HISTORIC AND DESIGN REVIEW COMMISSION

June 05, 2019

HDRC CASE NO: 2019-298
ADDRESS: 111 SOLEDAD ST
LEGAL DESCRIPTION: NCB 909 BLK LOT 17
ZONING: D, H, RIO-3
CITY COUNCIL DIST.: 1
DISTRICT: Main/Military Plaza Historic District
APPLICANT: Ashley Farrimond/Kaufman & Killen, Inc.
OWNER: RIVERVIEW TOWER PRTNR LTD
TYPE OF WORK: Signage, exterior alterations, construction of a rooftop bar area
APPLICATION RECEIVED: May 17, 2019
60-DAY REVIEW: July 16, 2019
CASE MANAGER: Edward Hall
REQUEST:

The applicant is requesting conceptual approval to perform exterior modifications to the existing structure at 111 Soledad. The applicant has proposed the following:

1st floor changes

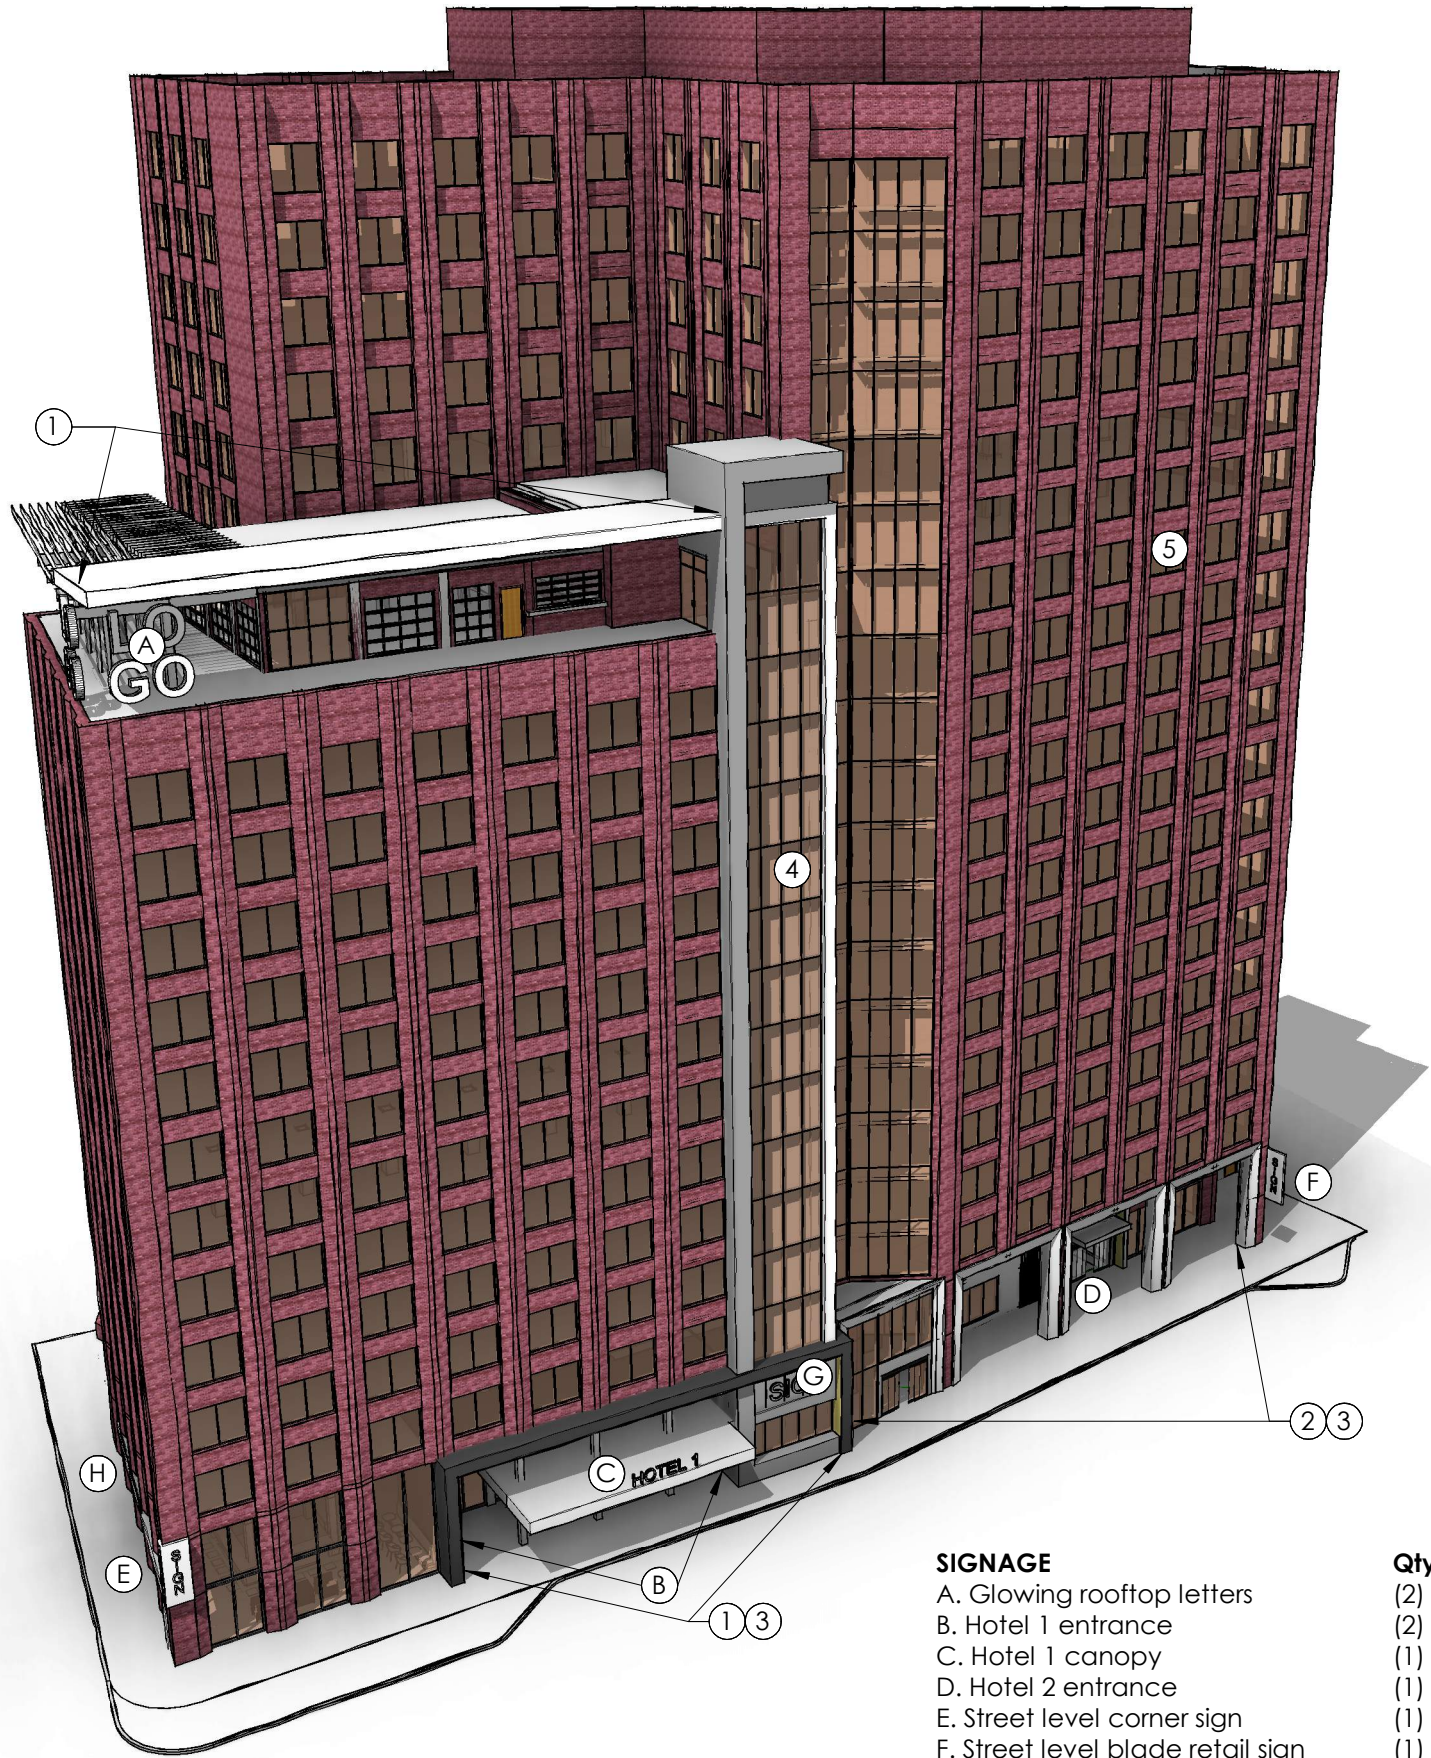
- d. EXTERIOR MODIFICATIONS (Street level) – The applicant has proposed to modify the street level façades on both Soledad (east) and E Commerce (south) to feature entrance elements that more adequately address pedestrian traffic and the human scale. These modifications include the installation of entrance canopies, in addition to new and detailed pedestrian entrances. The UDC Section 35-673 provides standards for pedestrian entrances, including arranging entrances in a hierarchy. The UDC Section 35-674 notes that entrances shall be the most prominent on streets, shall be places to be highly visible, shall have a change in material and/or wall plane and should not use excessive storefront systems. The proposed modifications to entrances on both Soledad and E Commerce and consistent with the UDC.

- f. **SIDEWALK** – At the street level on Soledad, the applicant has proposed to modify the existing sidewalk to feature a vehicular access point to accommodate valet parking. This would require the removal of portions of the public sidewalk; however, the applicant has noted that the existing pedestrian pathway within the structure’s existing colonnade would be open to pedestrians. Per the submitted site plan, a width of six (6) feet will be maintained on the sidewalk at all times. The applicant shall coordinate with the City of San Antonio Center City Development Office, Transportation and Capital Improvements and the Disability Access Office in regards to the street level details, width of public walkways and public access across the site.

- 3. Staff recommends approval of item number 3, modifications to the street level facades based on finding d.
- 4. Staff recommends approval of item number 4, modifications to the west façade based on finding e.

- 5. Staff recommends approval of item number 5, modifications to the existing pedestrian sidewalk with the following stipulations:
 - i. That the applicant coordinate with the City of San Antonio Center City Development Office, Transportation and Capital Improvements and the Disability Access Office in regards to the street level details, width of public walkways and public access across the site.
